PLANT SYSTEMS

PROOF & REVIEW COPY

3/4.7.9 SNUBBERS

FIGURE 4.7.1 SAMPLING PLAN FOR SNUBBER FUNCTIONAL TEST

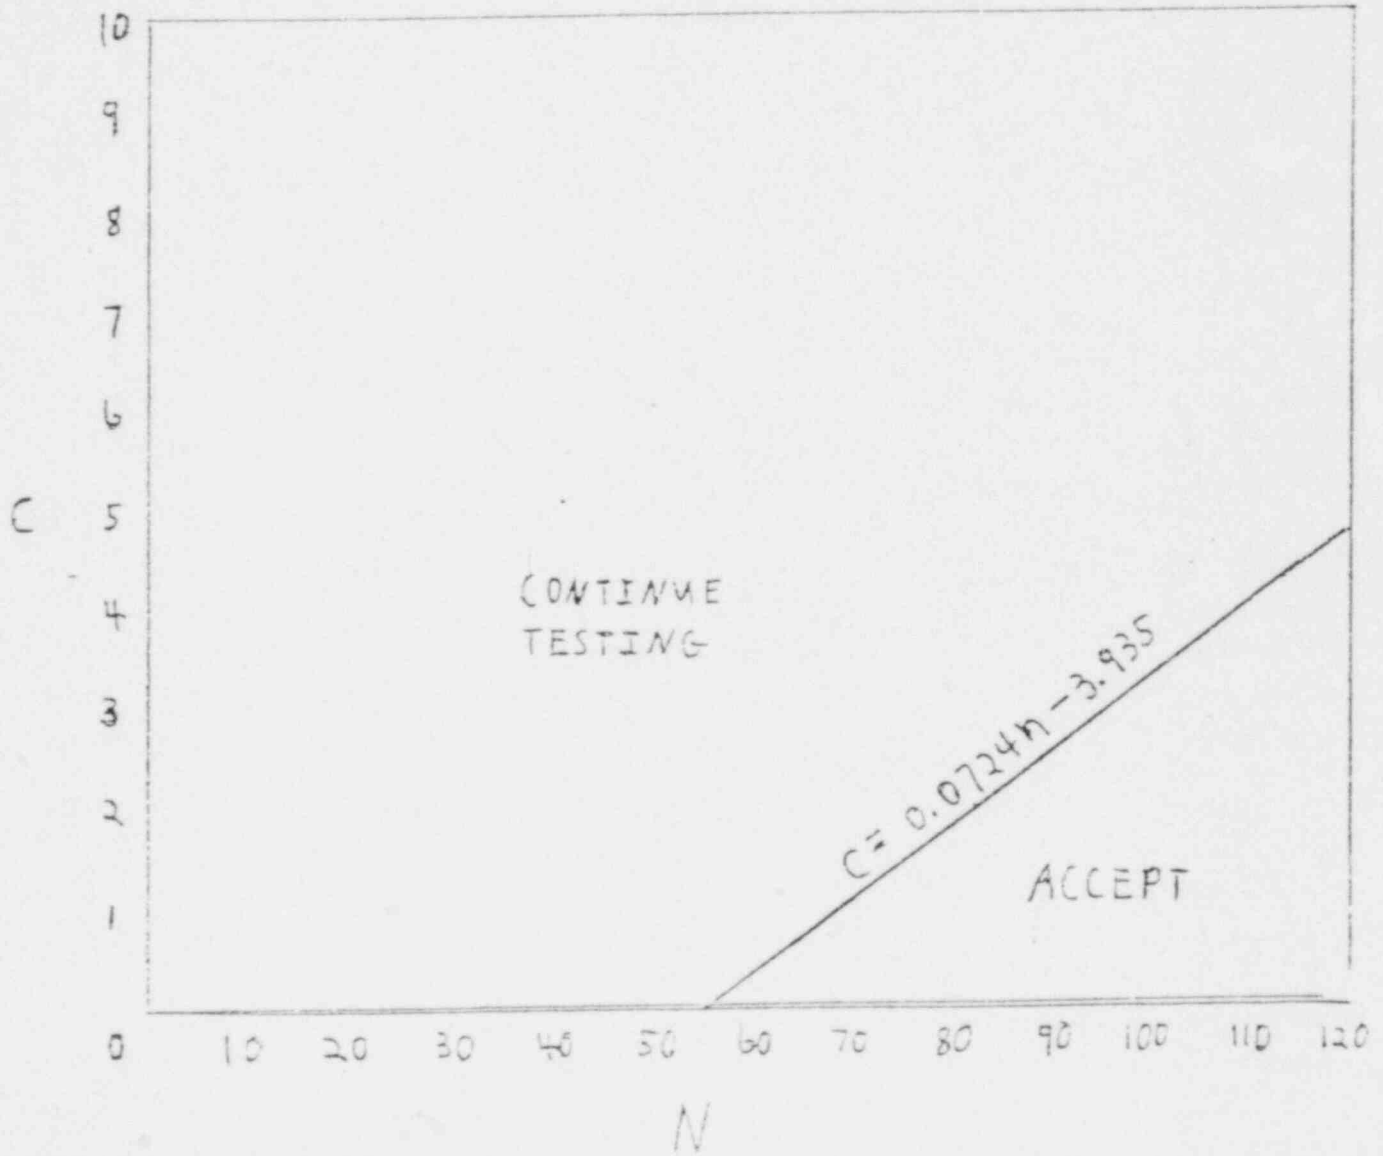
4.7.9.c. Revise the circled portion pertaining to mechanical snubbers as follows:

For mechanical snubbers, a representative sample shall be functionally tested in accordance with Figure 4.7.1. On Figure 4.7.1, "C" is the total number of mechanical snubbers which are found to not meet the acceptance criteria. The cumulative number of snubbers tested is denoted by "N". As testing continues, the values of "N" and "C" are plotted on Figure 4.7.1. If at any time the point plotted falls in the "Accept" region, the testing shall be terminated. When the point plotted lies in the "Continue Testing" region, additional snubbers shall be tested until the point falls in the "Accept" region, or all mechanical snubbers in Table 3.7.9-2 have been tested. However, if at any time during the testing after at least 55 snubbers have been tested, the snubber failures can be attributed to a particular size of snubber, or application, or operating environment, or linked to a particular occurrence such as water hammer, additional snubber testing may be limited to such generically susceptible snubbers. Such testing would continue until the points plotted on Figure 4.7.1 fall in the "Accept" region or until all generically susceptible snubbers of Table 3.7.9-2 have been tested.

Bases:

The alternate sampling plan provides an equivalent confidence level as that proposed in the Bases section of this Specification. Also, more benefits can be derived from functional testing if the cause of failure can be identified. This enables more effective corrective action. In requiring that at least 55 snubbers be tested before utilizing a generic approach, confidence would be provided that there is not a problem with the snubbers outside the generic problem group. By limiting additional testing to a group generically susceptible, increased reliability is provided without jeopardizing the balance of the snubbers which do function properly.
